Hoja de modificaciones 2

Orden de producción: DG-17011-IK

Cliente: MAIA SPACE

PROJECT	DG-17011-IK	Date	30/01/2024
Drawn	mip	Checked	R. Torrell
Checked		Date	30/01/2024
SCALE	CRYOGENIC STORAGE TANK		
	VERTICAL TYPE		
	SERIES DCV-250-060-18		
	(50m3/18bar)		
P&I			
No	900

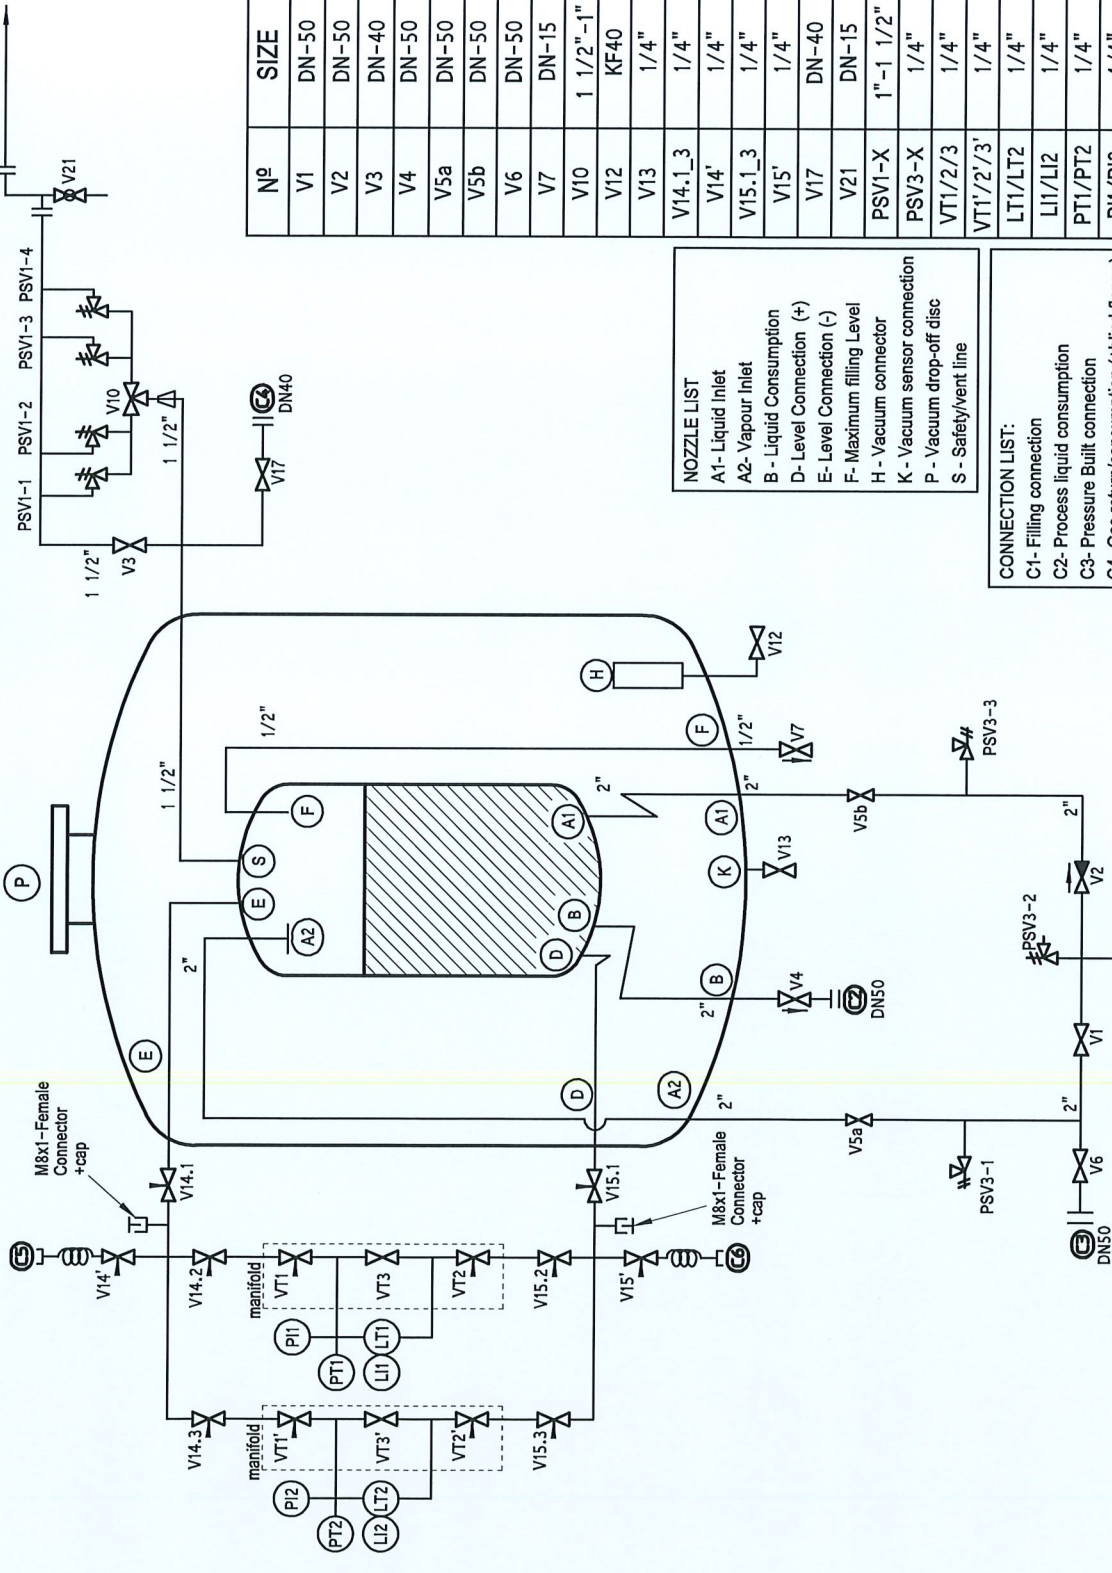
Ud.	Denominación	Precio unitario	Importe PVP
*	Se añade conector Ariane en la fase liquida igual al que está previsto en la fase gas (ver P&ID adjunto)		
*			
*			
*			
		Total
